MUNICIPAL SOLID WASTE SLOPE FAILURE. I: WASTE AND FOUNDATION SOIL PROPERTIES^a

Discussion by Edward Kavazanjian Jr.,⁵
J. F. Beech,⁶ and Neven Matasović,⁷
Members, ASCE

Closure by Hisham T. Eid,⁸ Timothy D. Stark,⁹ W. Douglas Evans,¹⁰ and Paul E. Sherry¹¹

FIG. 8. Stress Dependent Shear Strength of MSW

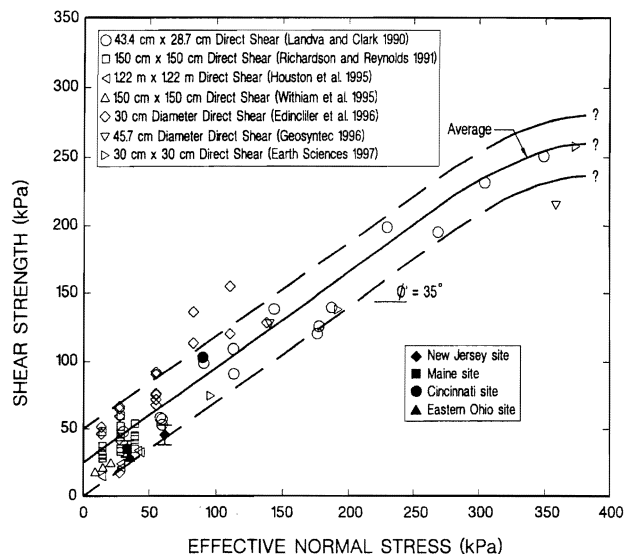
One of our primary concerns is the "average" straight-line MSW failure envelope presented in Fig. 5, established by linear regression analysis. Use of a straight-line failure envelope automatically precludes consideration of any nonlinear, confining pressure dependence in waste shear strength. We note that, above a confining pressure of 150 kPa, corresponding to

approximately 10–15 meters of waste, nine out of the ten data points in Fig. 5 are below the authors' best-fit straight line. This strongly suggests that a single straight line should not be fit to the data and that the authors' average strength envelope may overpredict shear strength at higher confining pressures.

The writers welcome the discussers' comments. The failure envelopes proposed for municipal solid waste (MSW) in Fig. 5 are intended to be used for effective normal stresses less than 400 kPa, as indicated in Fig. 5. Reevaluating the shear strength data for effective normal stresses greater than 250 kPa suggests that the trend lines may be stress dependent or non-linear, as shown in Fig. 8. However, the amount of data at effective normal stresses greater than 250 kPa is sparse. The revised failure envelopes shown in Fig. 8 do not alter the analysis of the slope failure in the companion paper (Stark et al. 2000), because the effective normal stress acting on the steeply inclined portion of the shear surface passing through the MSW is less than approximately 270 kPa.

In summary, experience with a number of recent waste slope failures suggests that MSW exhibits a high shear strength under static conditions that can be characterized by the average failure envelope (effective stress cohesion = 25 kPa and friction angle = 35°) in Fig. 5 for effective normal stresses less than or equal to 250 kPa. At effective normal stresses greater than 250 kPa, the failure envelopes may be stress dependent, as suggested by the discussers, but the current data is limited

and thus question marks are shown in Fig. 8 near an effective normal stress of 400 kPa. Thus, it is recommended that testing and stability evaluations focus on the materials underlying the MSW, e.g., soils and/or geosynthetics.
